### **Amendments to the Drawings**

## **Remarks**

Applicants' remarks address each issue raised in the office action of September 27, 2005, and are presented in the same order.

FIG. 3

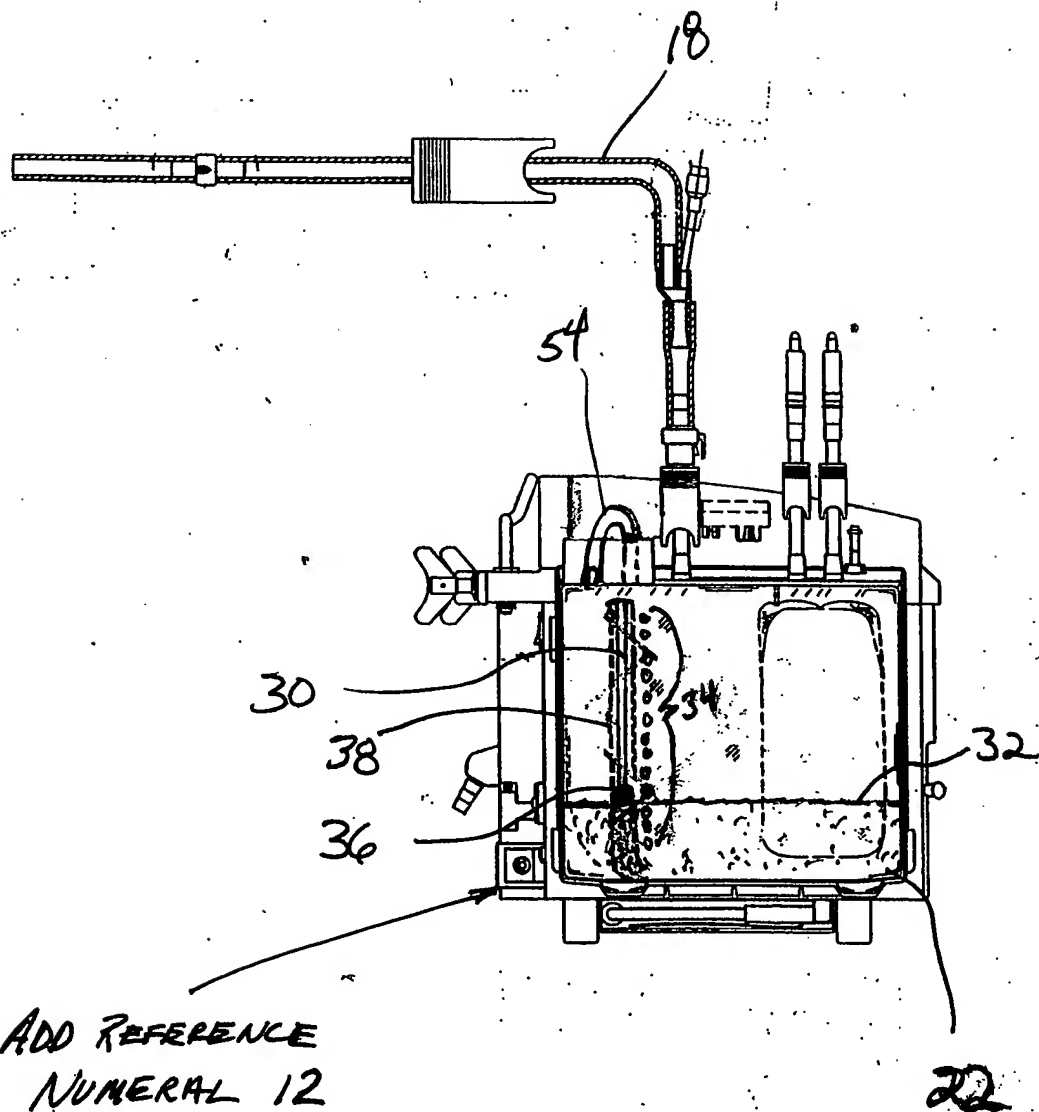
The sheet including FIG. 3, replaces the original sheet including FIG. 3. In FIG. 3, reference numeral 12 has been added.

Applicants have addressed the objection to the drawings made in the action by correcting the written disclosure as specified below. The objection was that reference numeral 34 identified two elements: the collection device housing and the array of lights. FIGS. 3 and 5 correctly show 34 as the array of lights. The ambiguity regarding 34 arose in the specification at page 12, last paragraph, in which the collection device housing was referred to with number 34. Reference numeral 34 has been deleted from

To help clarify the components in the drawings, FIGS. 3 and 5 have been amended to include a reference numeral 12 to identify the collection device. Annotated and replacement sheets are enclosed.

FIG. 5  
 ANNOTATED SHEET SHOWING CHANGES

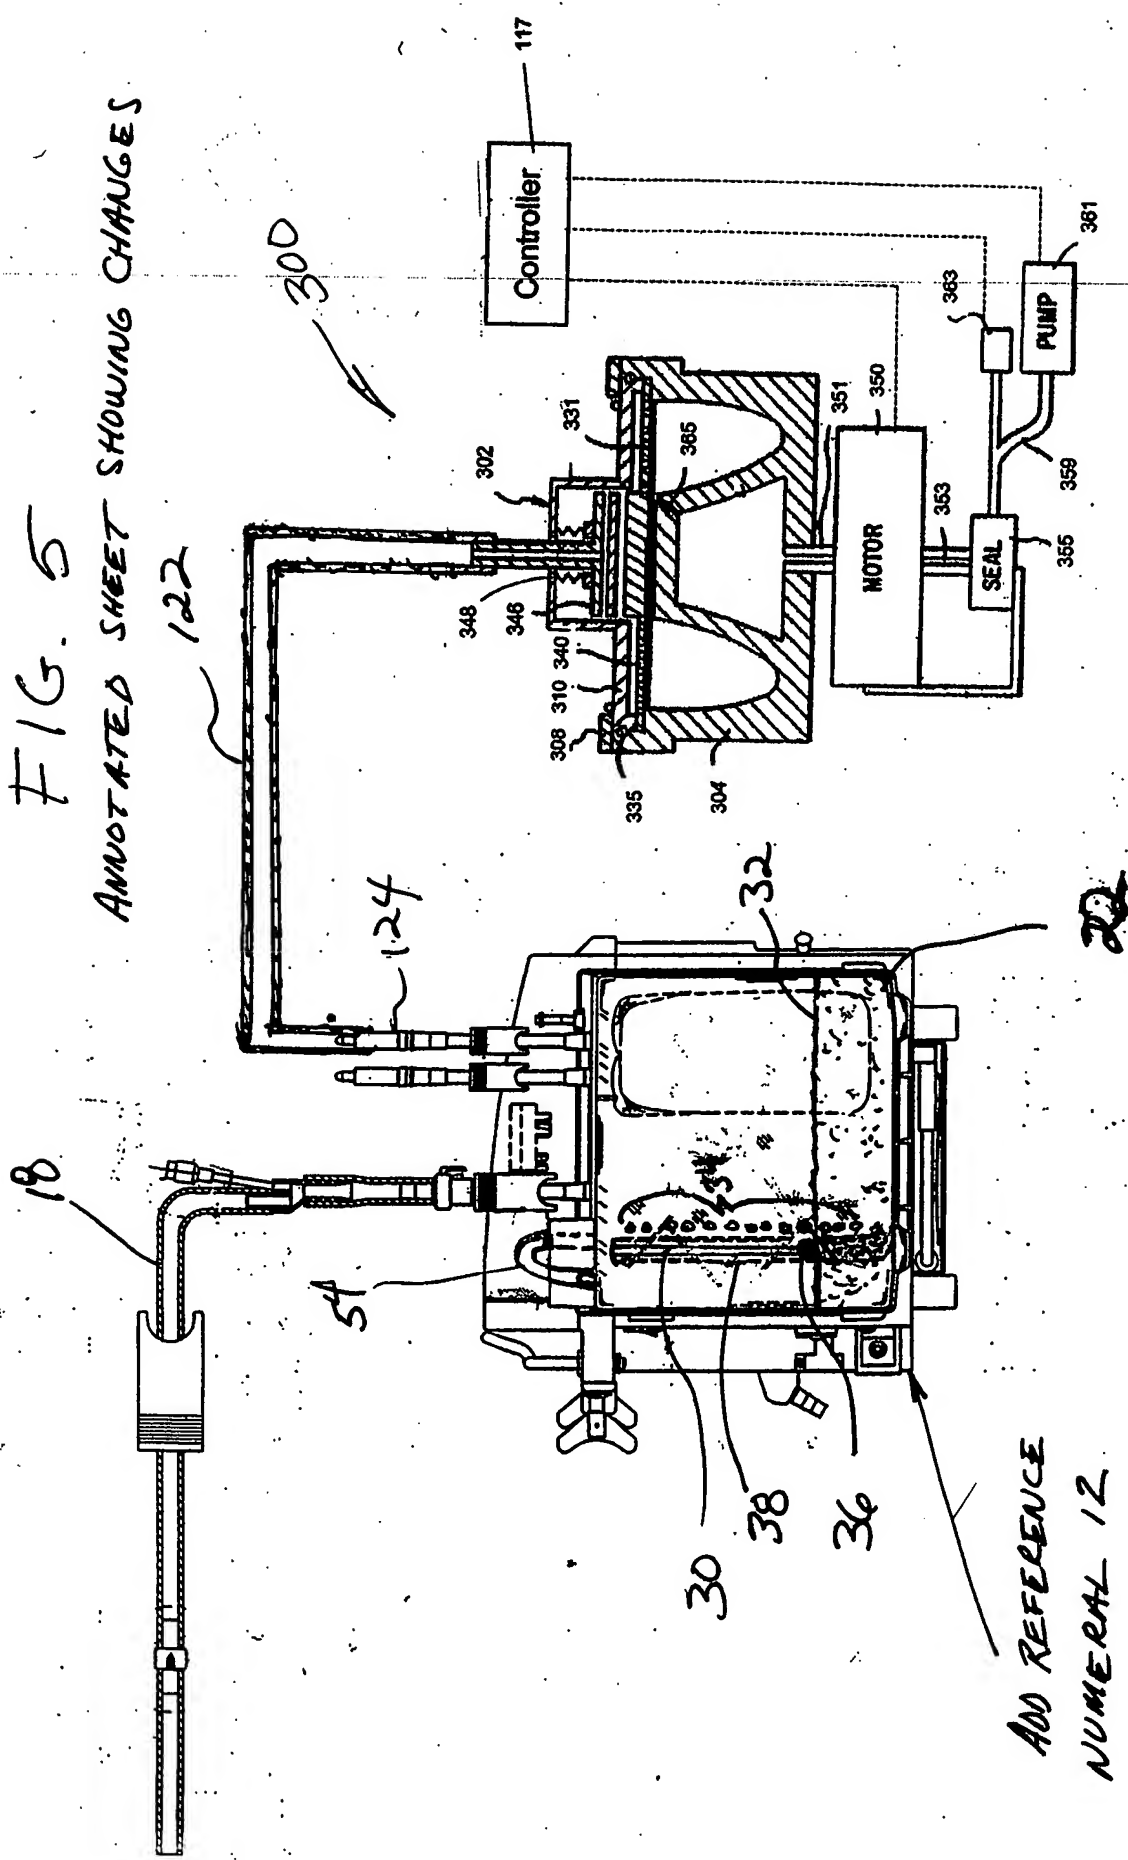
The sheet including FIG. 5, replaces the original sheet including FIG. 5. In FIG. 5, reference numeral 12 has been added.

ADD REFERENCE  
 NUMERAL 12
